# Quantum™ HD Release Notes

OS Version 10.17

Released 7-14-2014

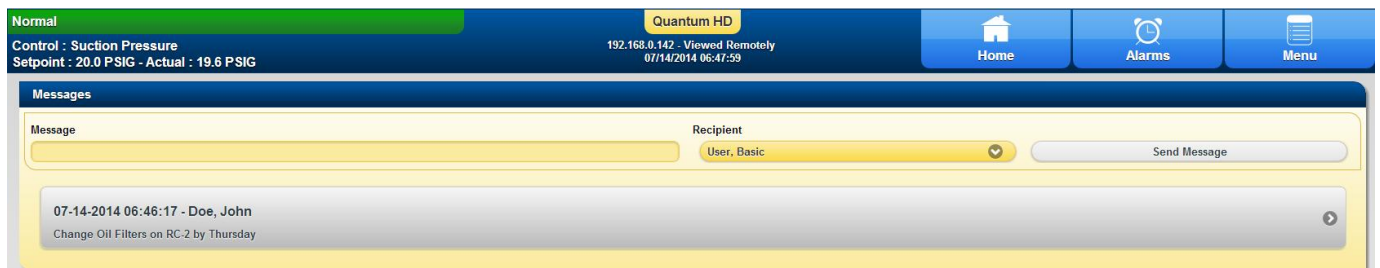
- A Message Board/Log was added and can be accessed by a file tab along the top of the Home Screen when logged into the Quantum HD. This message board/log can be used for one operator to send a message to another operator or to communicate items from one shift to another. If a message/s has been left for you from another operator a number representing the number of messages that you have will be seen next to the messages tab as shown below. Touch the Messages tab to access your messages.

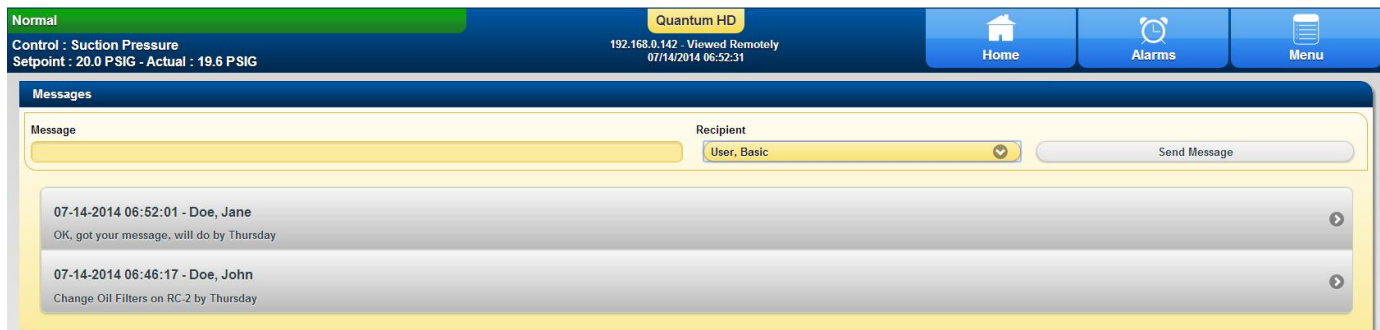
On the message board the time dated message along with the senders name is displayed. This page can be used to reply to the original sender as well.

## Login Touch-Pad

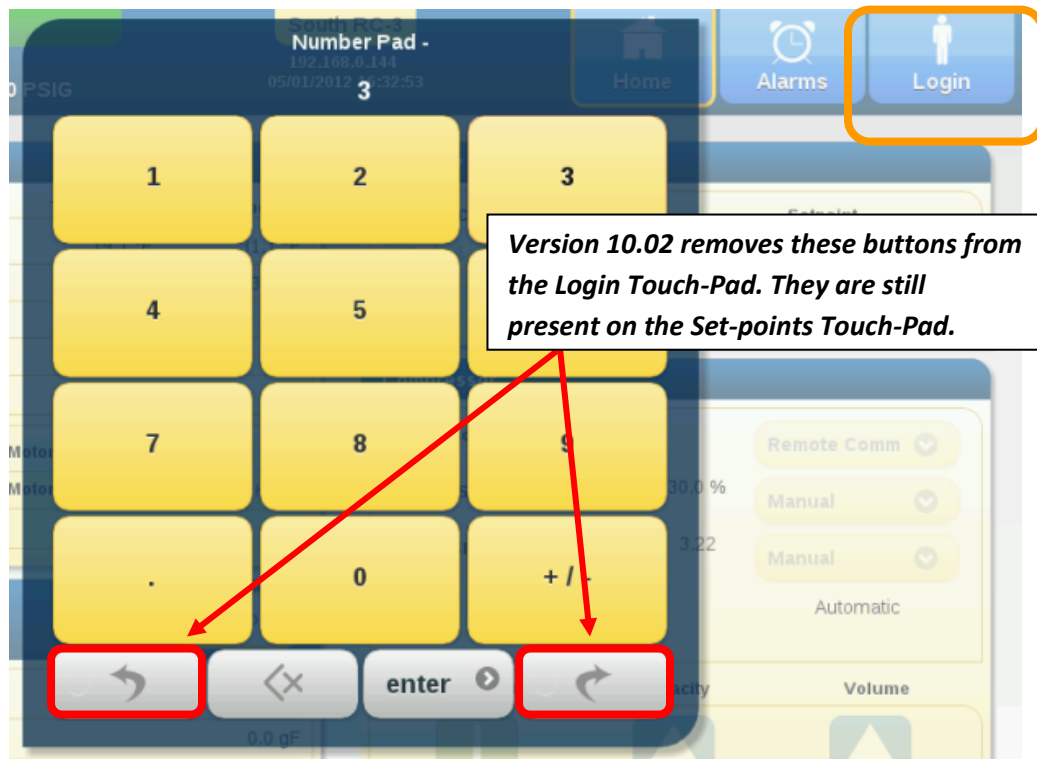
1. Fixed issue where the touch screen navigation would lock up during the Login process if either the Forward or Back button is touched. These buttons are not needed for the Login function and have been removed.
